SUBJECT: Requests change to Tech Spec Figure 6.2.2-1 re site organization & Table 3.6.3-1 re primary containment isolation valves. Proposed draft Tech Specs & affidavit encl.

Re: Nine Mile Point Unit 2  
Docket No. 50-410

Subject: Justification for changes to Technical Specification Figure 6.2.2-1

Subject: Justification for changes to Technical Specification Table 3.6.3-1

Figure 6.2.2-1  
NINE MILE POINT NUCLEAR SITE ORGANIZATION

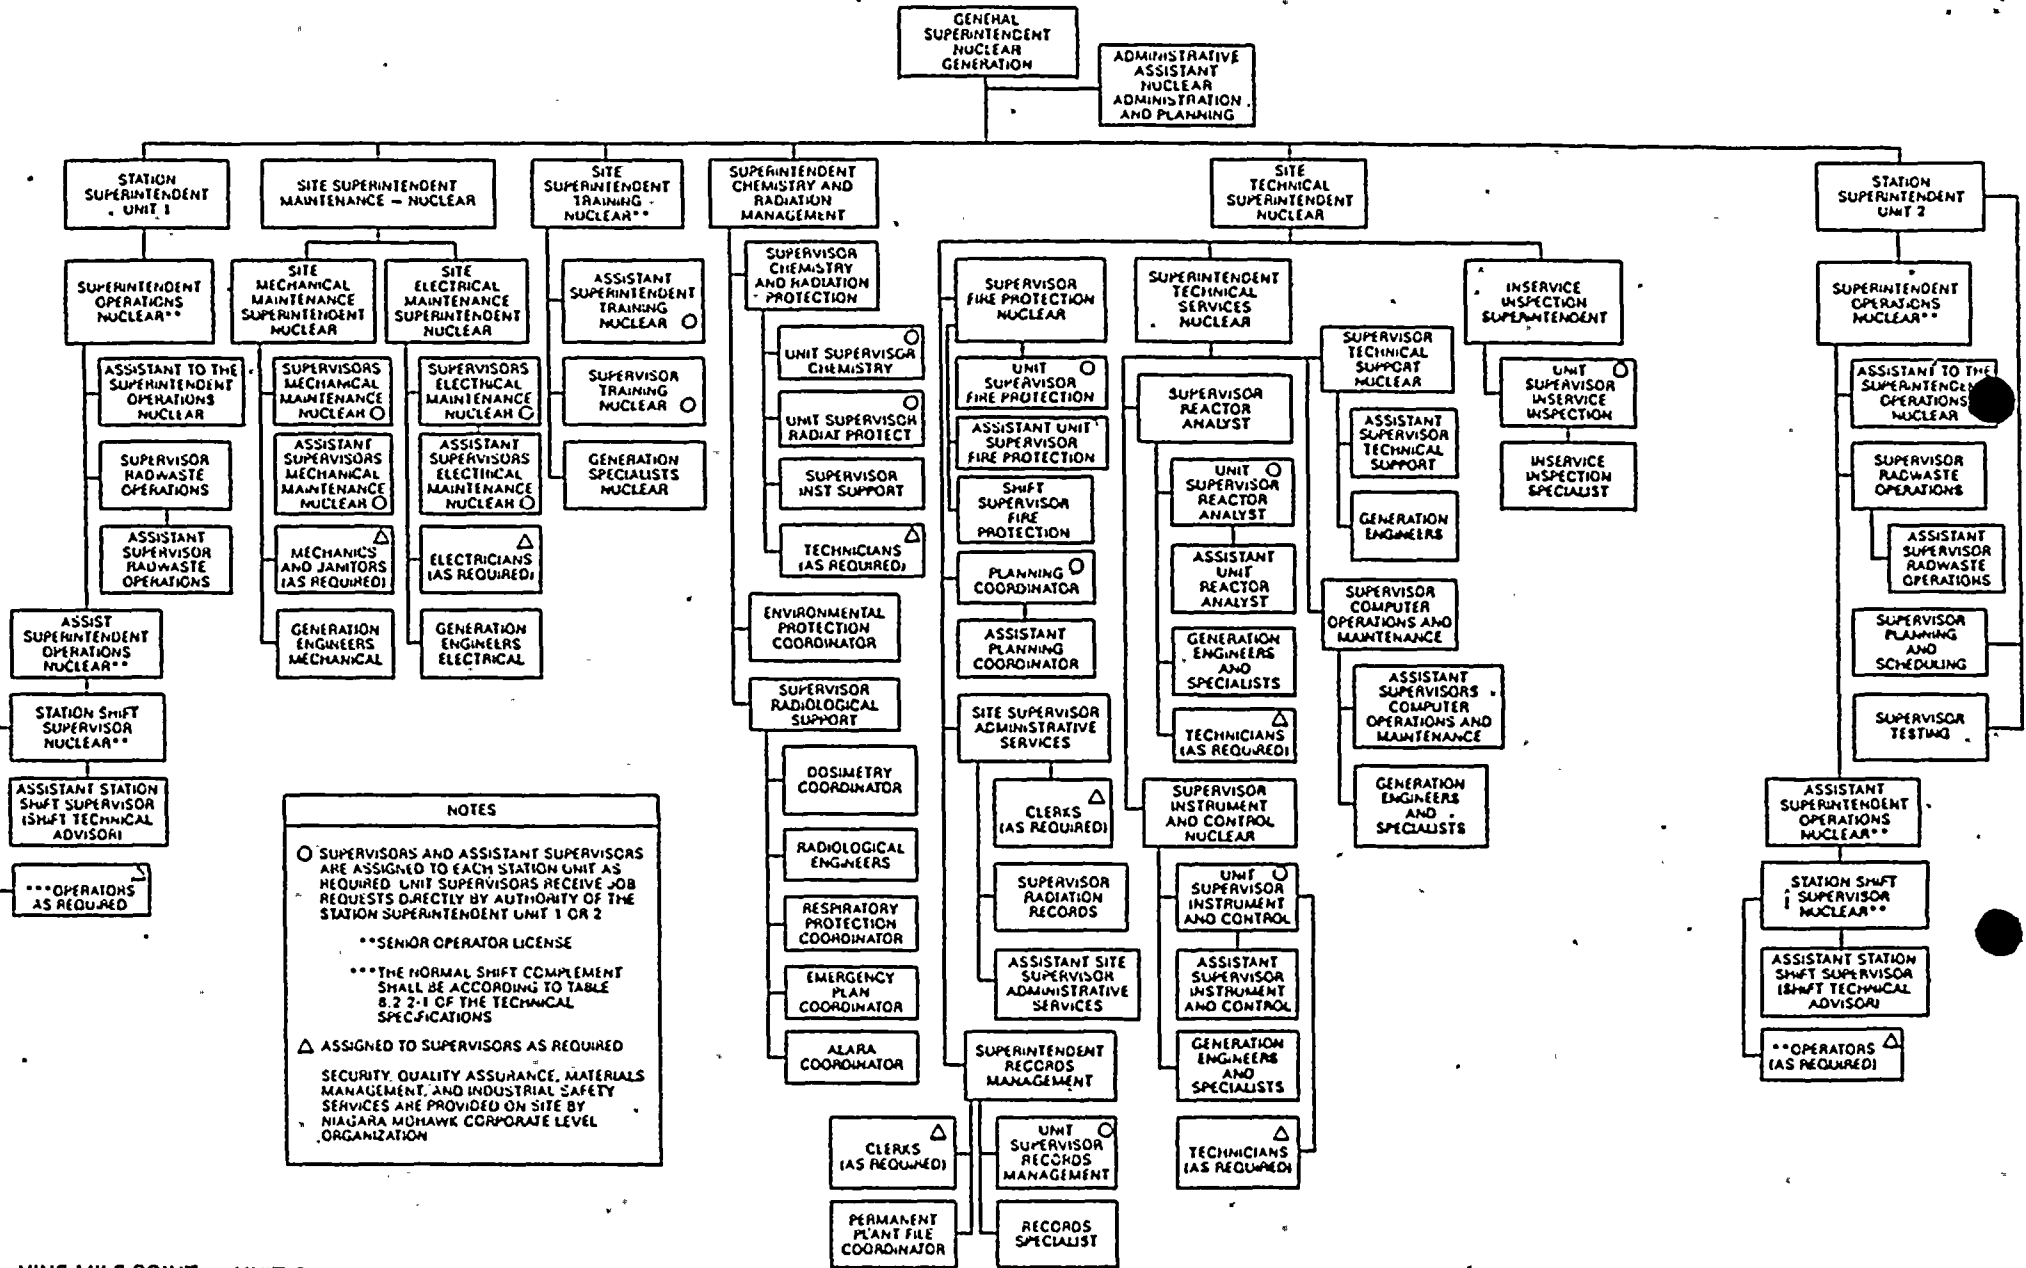
A copy of the change to Technical Specification Figure 6.2.2-1 is enclosed. This copy is identical to the marked up final draft version of Figure 6.2.2-1 submitted as page 40 of our letter dated August 21, 1986 (NMP2L 0836). Enclosed are the proposed Final Safety Analysis Report change pages in order to make the Technical Specification and Final Safety Analysis Report consistent with one another. The changes made to the Technical Specifications are the result of our verification program and represent the site organization as it will exist at fuel load. The changes are based upon the following factors:

- 1) Changes are made to reflect the sharing of site support functions for both Unit 1 and Unit 2 in the areas of maintenance, training, chemistry and radiation management, and technical support.

- 2) Changes are made which represent the minor title changes due to the evolution of the corporate structure.
- 3) Changes in the organizational structure of the training, fire protection and instrument/control support function allows better upper management control/direction of subordinate functions related to the daily activities associated with fire fighters, engineers and technicians.

- 4) Changes to the inservice inspection support function represent the elimination of a "senior inservice inspection specialist" position and the consolidation of this function into two subordinate positions that directly report to the "inservice inspection superintendent". The consolidation of these functions enhances the direct management control of inservice inspection activities.

- 5) Changing the supervisor stenographic services to the supervisor radiation records reflects the importance of providing direct management supervision in maintaining radiation personnel exposure records. The stenographic support function still exists under the control of the site supervisor administrative services but is not shown in this organizational chart because of the level of detail associated with this diagram.

- 6) The creation of the "supervisor planning and scheduling" and "supervisor testing" positions represent the continuation of pre-fuel load activities which directly assist the station superintendent of Unit 2 in the successful execution of the startup power ascension testing program and associated planned outages.

- 7) The changes associated with the reporting responsibilities under the "assistant superintendent operations nuclear" for Unit 2 allows direct "station shift supervisor nuclear" control of chief shift and auxillary operators' daily activities. This in turn enhances the "station shift supervisor's nuclear" ability to control activities performed on his unit. A similar change was made to Unit 1 reporting responsibilities associated with the "assistant superintendent operations nuclear" function.

FIGURE 13.1-6

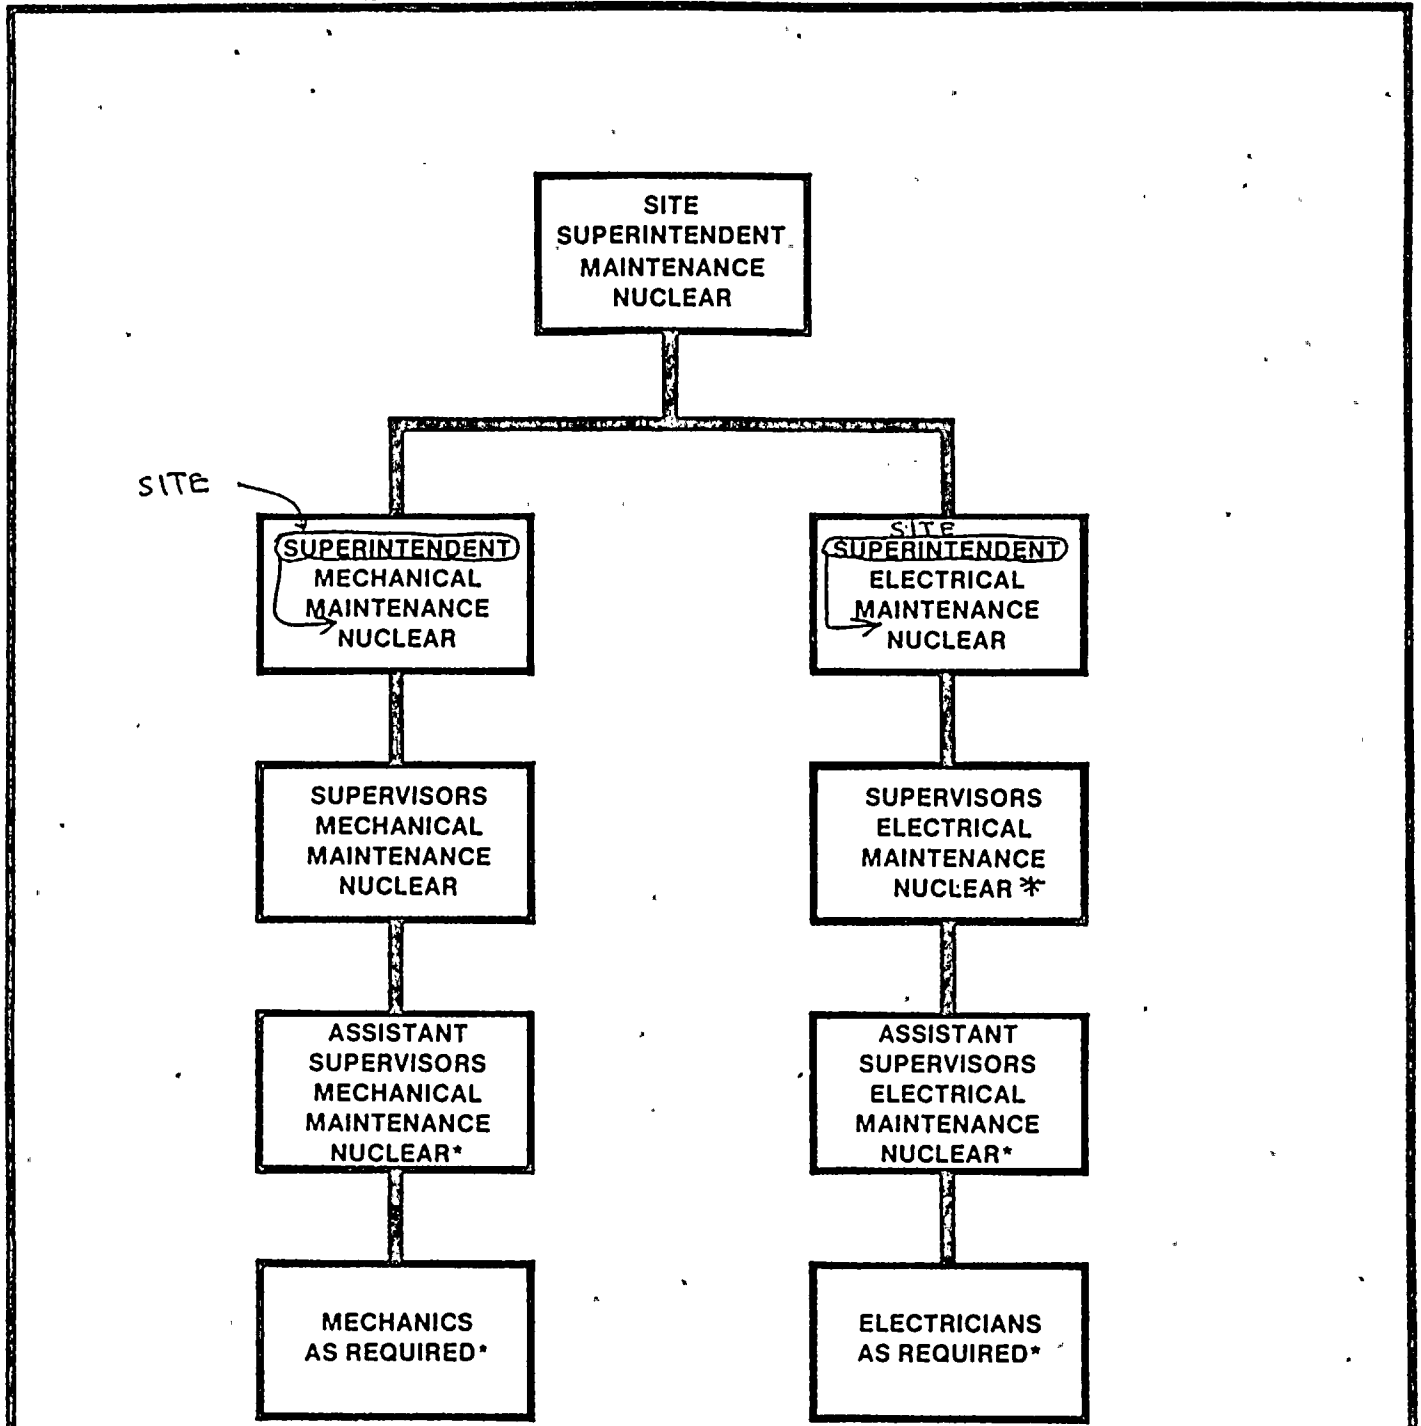
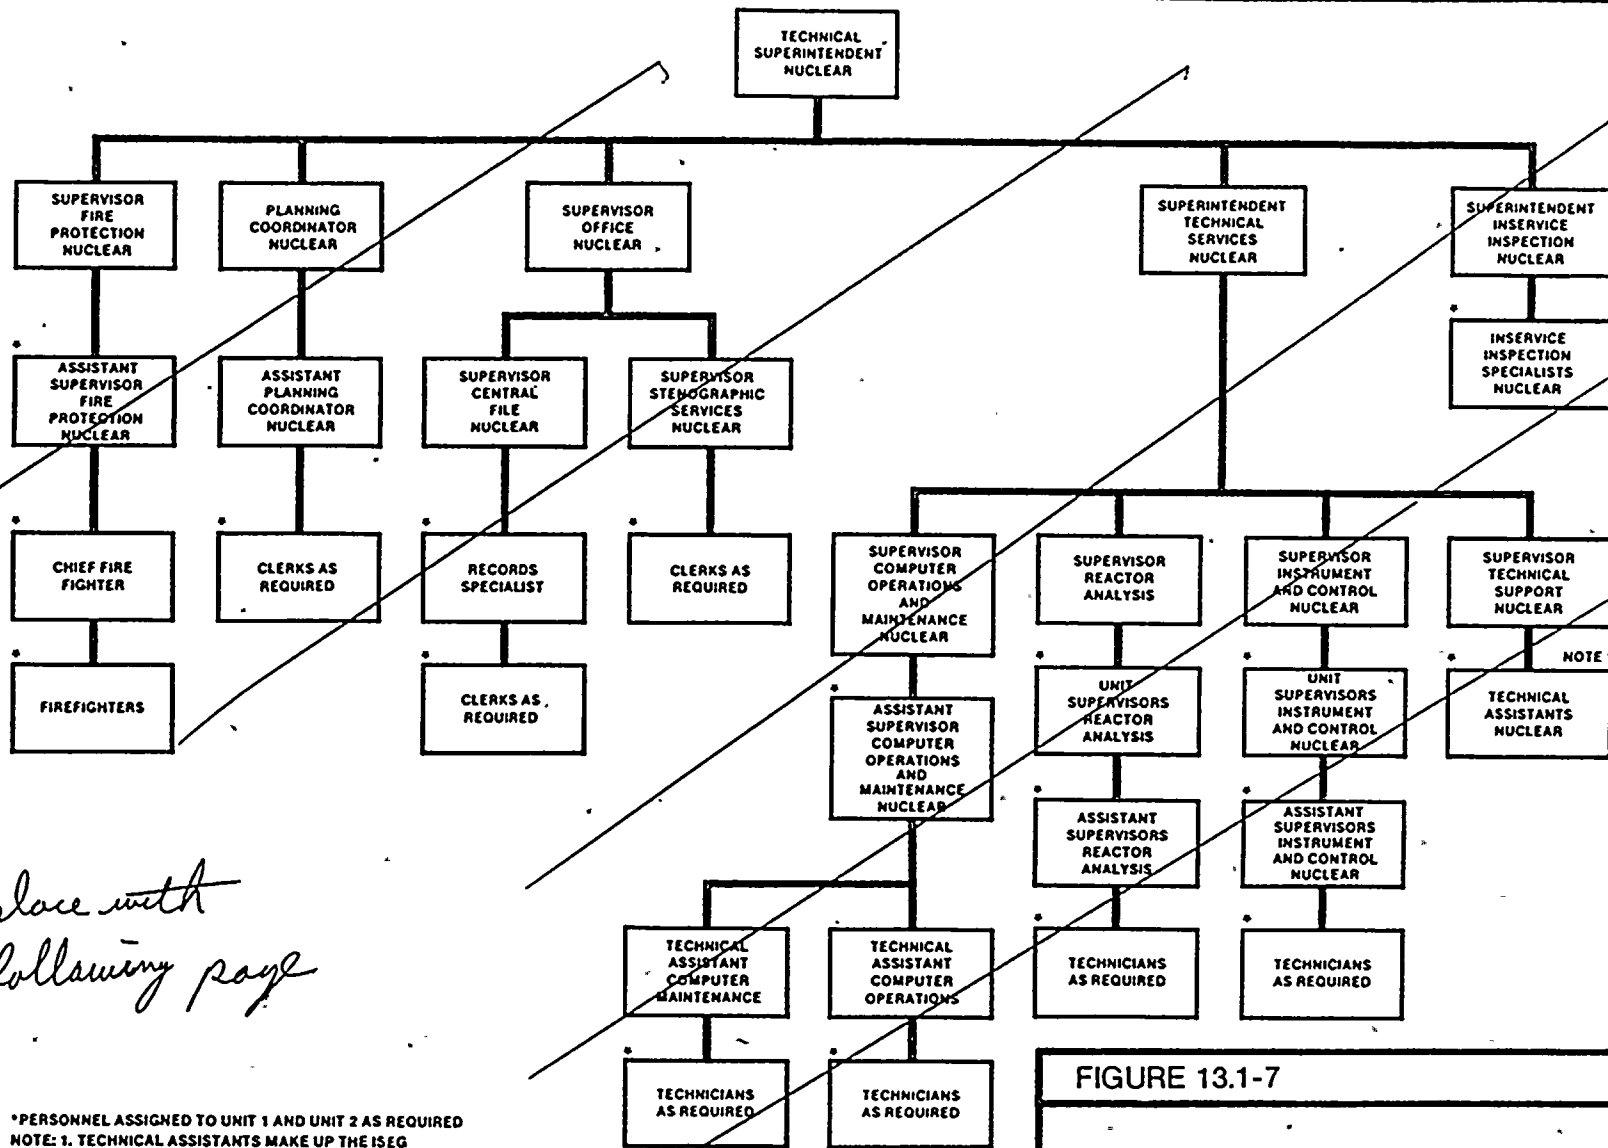
*replace with following page*
